BOARD ACTION REPORT – APPEALABLE ITEM

Project Name:	132 N Swinton Avenue
Project Location:	132 N Swinton Avenue
Request:	Certificate of Appropriateness (COA) and Class II Site Plan
Board:	Historic Preservation Board
Meeting Date:	May 1, 2019

STAFF REPORT

ITEM: 132 N Swinton Avenue, Old School Square Historic District – Certificate of Appropriateness (2019-136) and Class II Site Plan Application for exterior modifications to the existing structure and modification of the existing landscaping.

ELEVATIONS

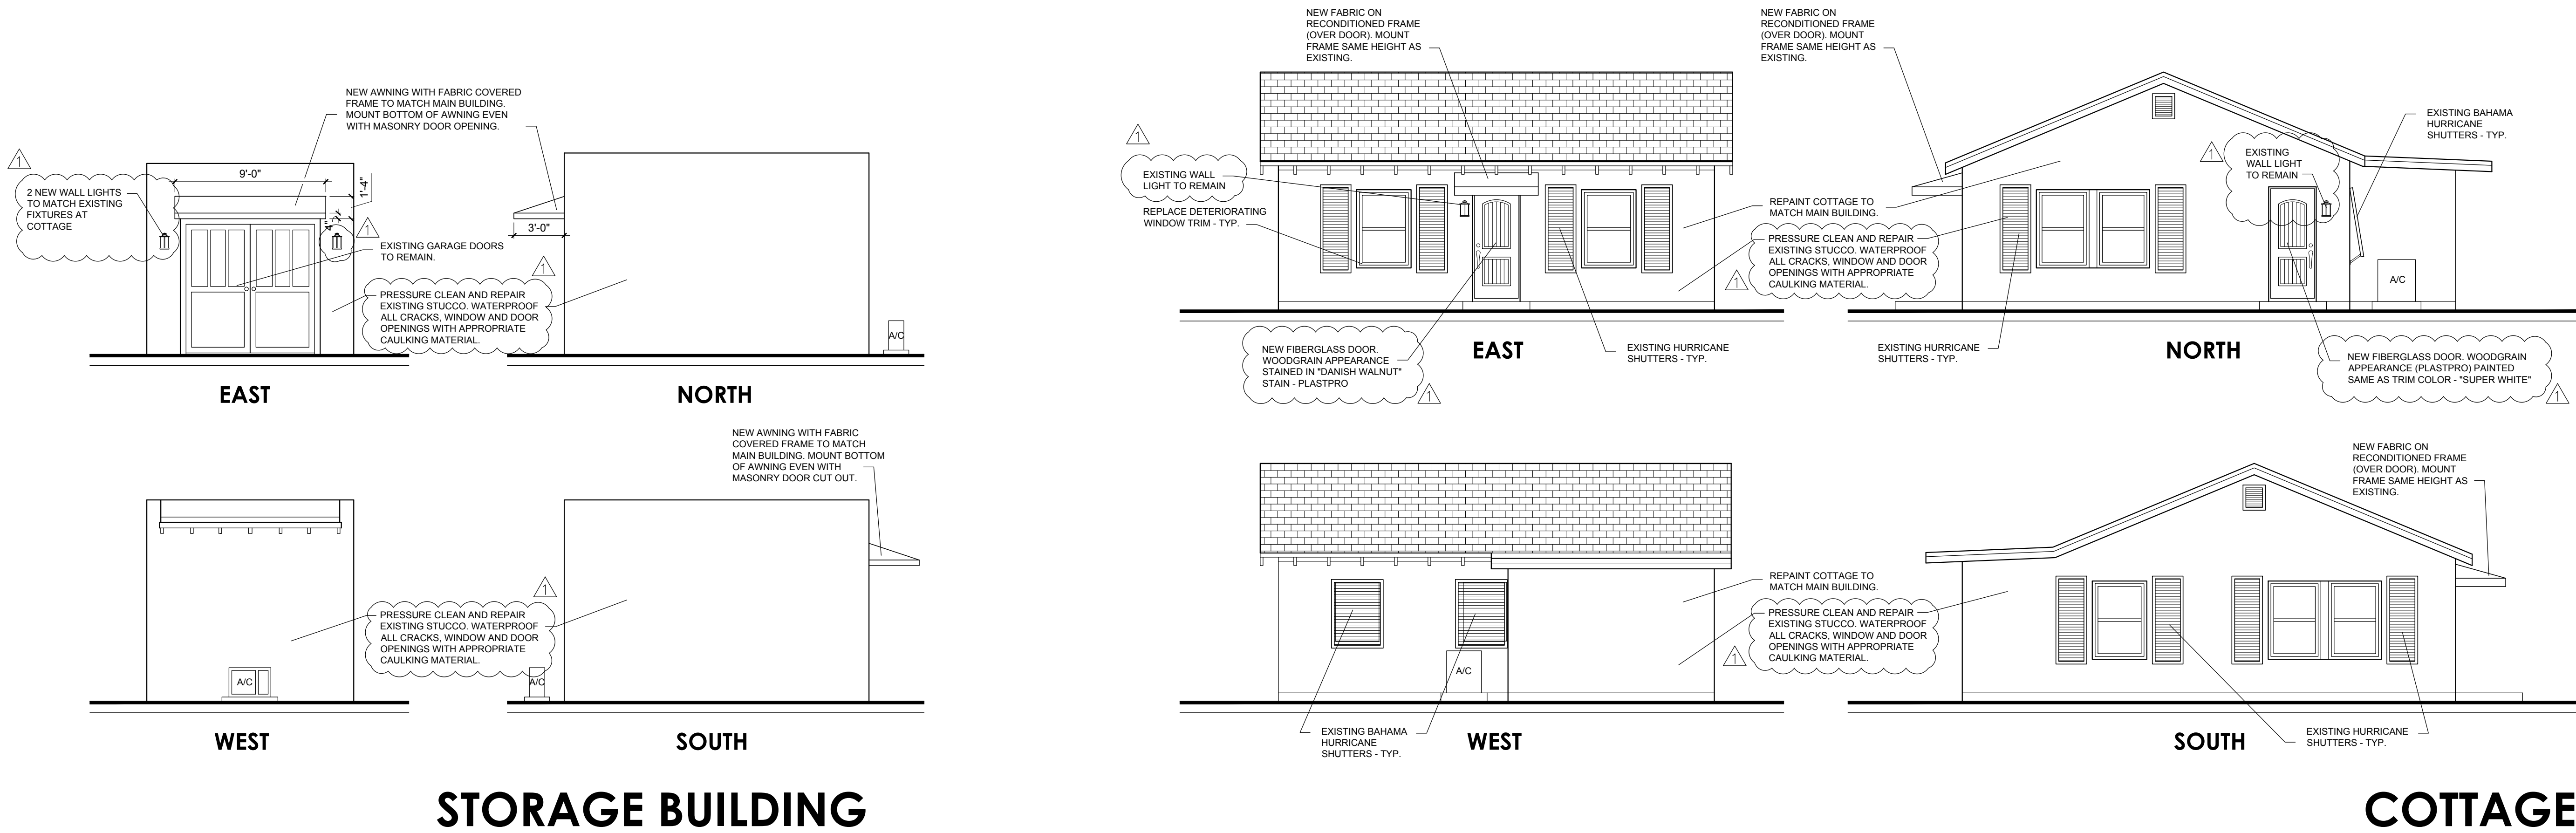
The proposed exterior modifications are in relation to the maintenance of the existing structures. The proposal includes the cleaning and repairing of the existing exterior stucco finish. The body of each of the structures will be painted a grey color noted as "Flannel Pajamas" with "Super White" trim and the awnings will be dark grey. The awning frames will be preserved and reconditioned for continued use. The existing single-pane, plexiglass type windows will be replaced with aluminum framed single-hung

windows with a 3 over 1, dimensional muntin pattern and non-reflective, clear glass. New fiberglass doors with a woodgrain pattern will replace the existing exterior doors. Existing decorative features such as plaques on the west and south elevations; the medallions on the north and east elevations, vent openings & parapet barrel tile on the east elevation will be preserved. The proposal also includes removal and replacement of existing landscaping.

Replacement of the existing single-pane, plexiglass type windows with aluminum single-hung windows with a 3 over 1, dimensional muntin pattern returns appropriate visual interest to the Mission architectural style of the structures and to the adjacent streetscapes. The proposal includes the cleaning and repairing of the existing stucco on all structures. An added condition of approval is that the existing rough stucco texture of the each structure be preserved. This will ensure the proposal meets the Visual Compatibility Standard of Relationship of Materials, Texture and Color providing for visual compatibility with the predominant materials used in the historic buildings and structures within the OSSHD. Additionally, the proposal includes preservation of existing decorative features such as the plaques on the west and south elevations, the medallions on the north and east elevations, the vent openings & parapet barrel tile on the east elevation. Finally, the removal and replacement of existing landscaping allows for additional updating and maintenance of the site.

1. That the foot-candles for the 2 light fixtures on the main building be reduced to minimize spillover onto adjacent properties to no more than 0.25;
2. That the existing rough stucco texture be preserved; and,
3. That staff have the authority to approve the color of the awnings to “champagne”.
